Customer Service Notice

Units Affected: DL/DM Series, D4000A Series, and DB37 Digger Derrick units
 (see attached list)

Control Handle Replacement

Figure 1 — Control Handle Types

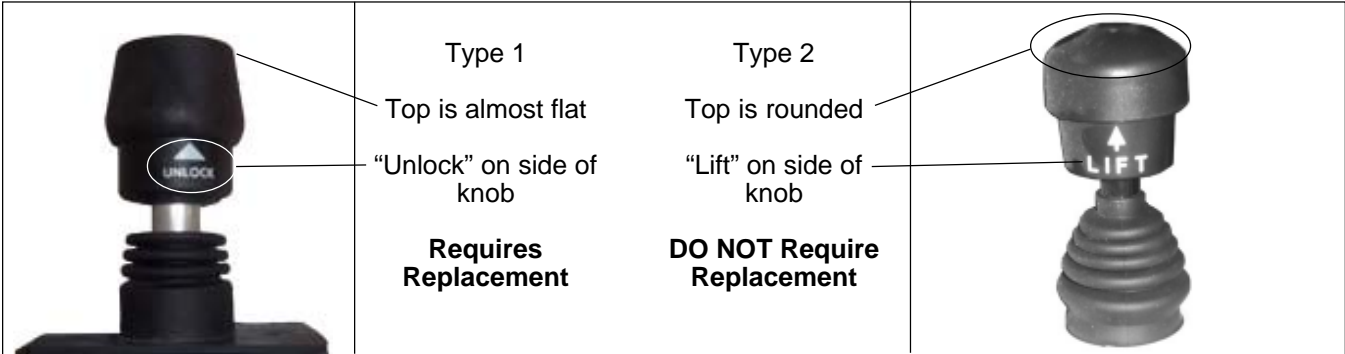
Altec has discovered some control handles on the listed units may have defects that allow enough movement of the handles with the interlock still engaged to activate a machine function. This movement can cause boom functions to operate causing unit movement. **Death or serious injury can result from unanticipated unit movement.**

Altec requires all affected units to have the control handles inspected within 90 days of receipt of this CSN. Two types of control handles are used on the units. Determine the type on the panel by comparing the control handles to those shown on Figure 1. If they look like type 1, the control handles must be replaced. If they look like type 2, no replacement is necessary. In either case, complete the CSN 550 Inspection sheet on Page 2 and fax it back to Altec.

A kit has been developed to provide the controls and instructions for the replacement. Order part number 970316777, Control Handle Replacement Kit for units requiring replacement (six control handles are in each kit). This repair is covered under the Altec Warranty Policy and can be performed by Altec or the customer's warranty provider. Altec will allow up to \$90 for the labor to perform this repair. A warranty claim must be submitted for the cost of the labor. Call 1-877-GO-ALTEC to schedule the work to be done by an Altec service technician. Customers are responsible for the travel costs of an Altec Mobile Service technician if the technician performs the inspection or repair at the owner's location.
